State of New Mexico
ENVIRONMENT DEPARTMENT

February 9, 2005

**RE: ADDITIONAL INVESTIGATION REQUIREMENTS AT SITES - SS-02&05, SD-08, SS-39
HOLLOMAN AIR FORCE BASE
EPA ID# NM6572124422
HWB-HAFB-04-009**

Figure 1. SS-39 SITE MAP WITH DPT GROUNDWATER SAMPLING LOCATIONS

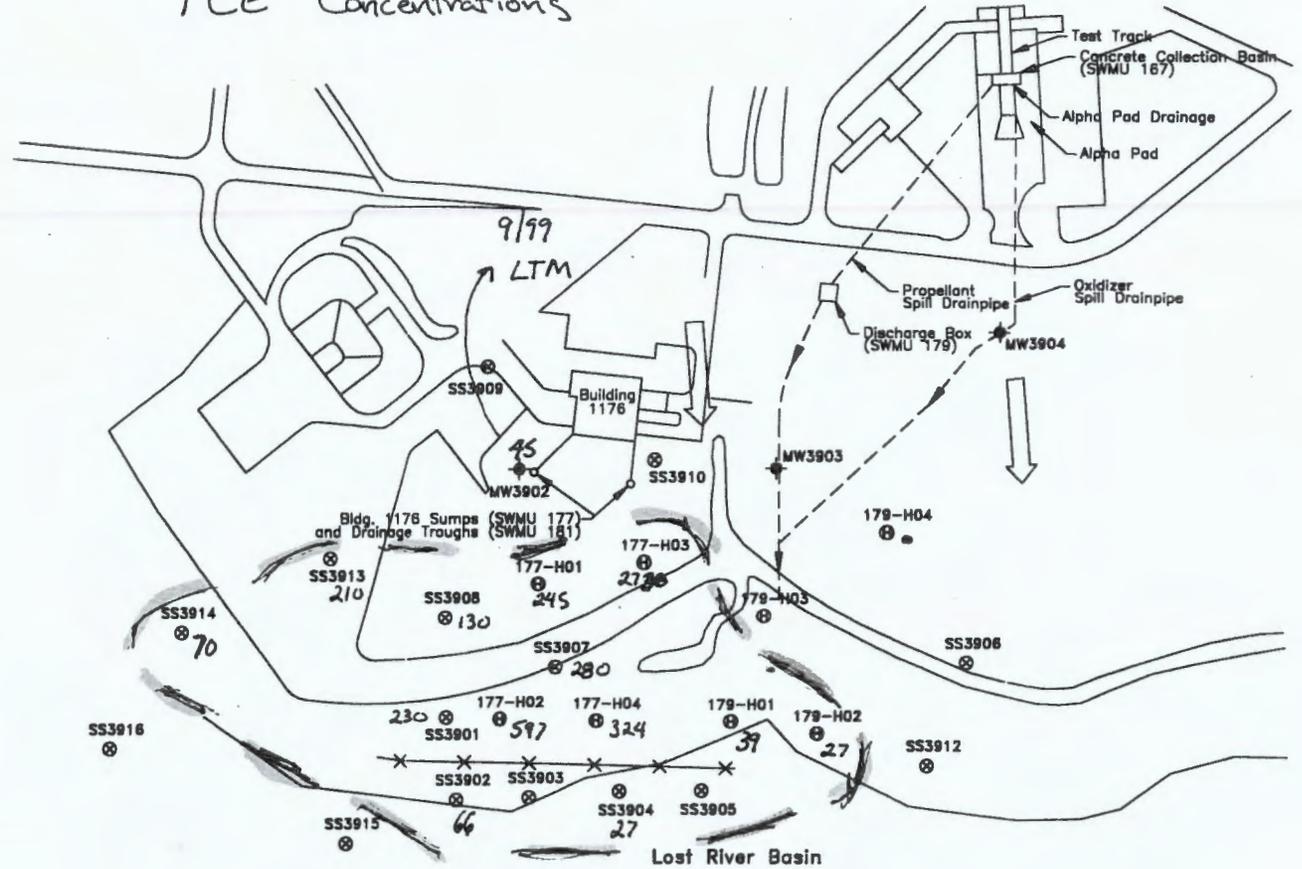
SS-39 SWMU 177 & 179

TCE Concentrations

Look in
 - Phase II, Table 2 RFI Report
 Radian 1994
 or
 - Phase I, Table 2, RFI Report
 Sept 97

2. Ground water monitoring wells shall be installed in area of highest contaminant concentrations and at down gradient locations. The distance between well(s) shall be no more than 200 feet, unless approved by NMED. The down gradient extent of the plume shall be defined where the concentration of TCE in the ground water is less than 5 mg/L. The wells shall be installed at the shallowest depth possible to yield representative ground water samples.

3. A vertical extent well shall be installed in the area of highest contaminant concentrations.
4. Initially, samples shall be analyzed for VOCs, SVOCs, RCRA metals, and perchlorate.
